## **ALERT SERVICE BULLETIN**

**412CF-20-69**

**MODEL AFFECTED:** 412CF

**SUBJECT:** ENGINE OIL CHECK VALVE P/N 209-062-520-001,  
INSPECTION AND REPLACEMENT OF.

Figure 3. Engine Oil Check Valve Outside Diameter Measurement

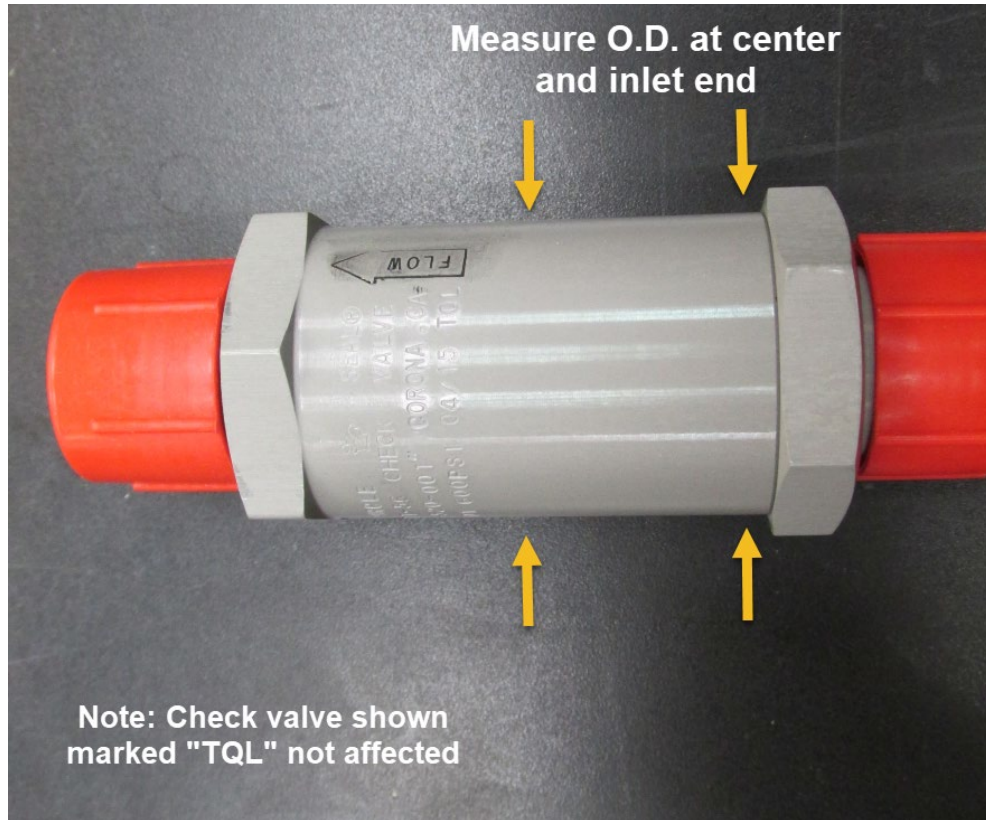
2. Verify if the check valves installed are affected by this bulletin.
3. If the check valves are not affected, make an entry in the helicopter logbook and historical service records indicating the findings and compliance with this Alert Service Bulletin.
4. If one or both check valves are affected, proceed as follows:
  - a. Using a caliper or equivalent, measure the check valve housing at the center and record dimension (Figure 3).
  - b. Measure the housing at the inlet end where the threaded fitting is installed and record dimension.
  - c. If the dimension measured at the inlet end is no more than 0.003 inch (0.0762 mm) greater than the measurement at the center, the valve is serviceable and

- d. If the dimension measured at the inlet end is greater than 0.003 inch (0.0762 mm) when compared to the measurement at the center, the valve will require replacement. Part III can be accomplished immediately, or Part II can be accomplished until the defective valve can be replaced in accordance with Part III.
- e. If the defective check valve is not replaced immediately, make an entry in the helicopter logbook and historical service records indicating the findings and that Part II must be accomplished every 25 flight hours or 30 days whichever comes first until Part III is accomplished.

Figure 4. Cracked Engine Oil Check Valve

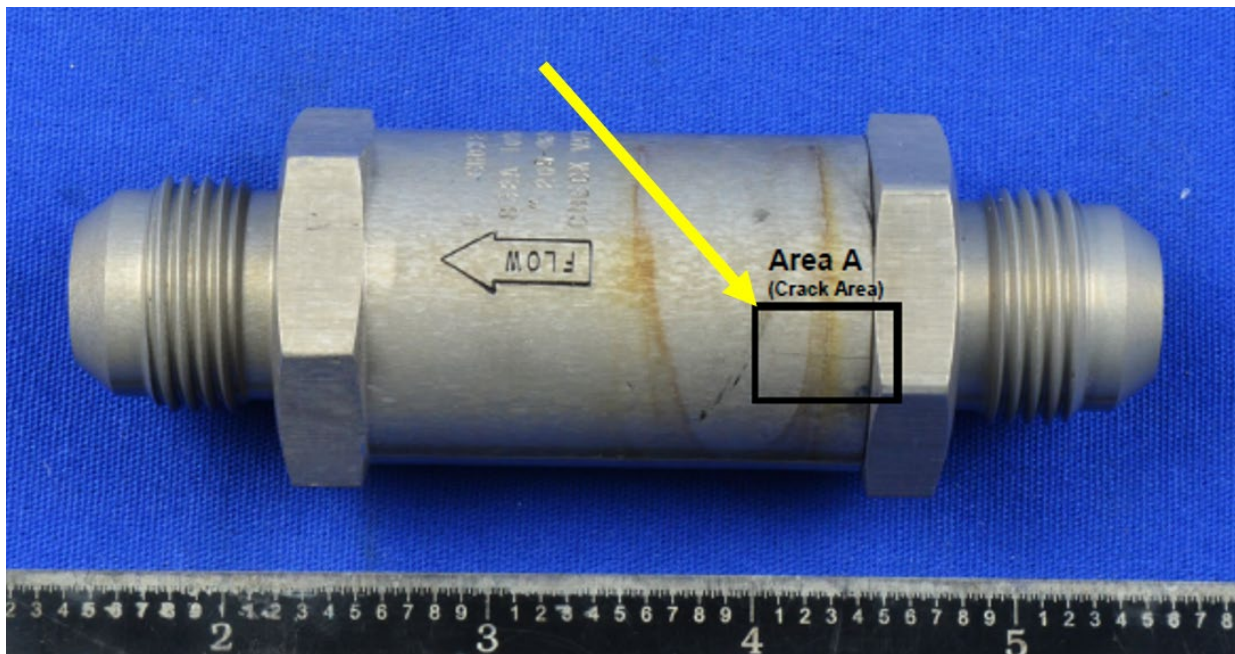
1. Prepare the helicopter for maintenance and gain access to the engine oil check valves (Figure 1, Details A and B).
2. Using a strong light source, visually inspect the oil check valves for general condition and oil leaks. Inspect for cracks at the inlet end where the threaded fitting is installed (Figure 3).
3. If a crack is found, replace the check valve prior to next flight. Figure 4 shows an example of a cracked check valve.
4. If no cracks or any other defects that would cause the valve to be unserviceable are found, make an entry in the helicopter logbook and historical service records indicating the findings and that Part II will require accomplishment until Part III is accomplished.
